PCN#20141119000A
Qualification of Alternate Assembly/Test Sites for Selected devices in the TSSOP Package
Change Notification / Sample Request

PCN Number:	20141119000A	PCN Date:	01/20/2015
Title:	Qualification of ASE Shanghai as an alternate Assembly/Test Site for Selected devices in the TSSOP Package		
Customer Contact:	PCN Manager	Phone:	Dept: Quality Services
Proposed 1st Ship Date:	03/03/2015	Estimated Sample Availability:	Provided upon Request

Sample product shipping label (not actual product label)

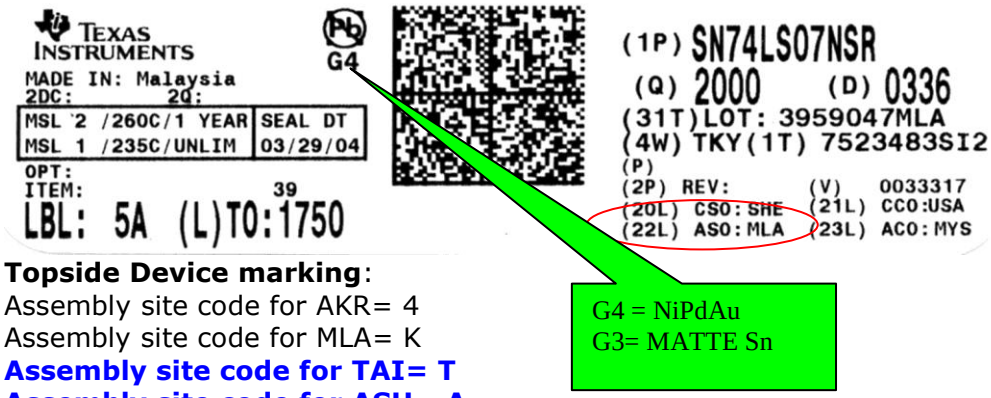
Assembly Site		
Amkor Philippines	Assembly Site Origin (22L)	ASO: AKR
TI Malaysia	Assembly Site Origin (22L)	ASO: MLA
TI Taiwan	**Assembly Site Origin (22L)**	**ASO: TAI**
ASE Shanghai	**Assembly Site Origin (22L)**	**ASO: ASH**

Topside Device marking:
Assembly site code for AKR= 4
Assembly site code for MLA= K
Assembly site code for TAI= T
Assembly site code for ASH= A
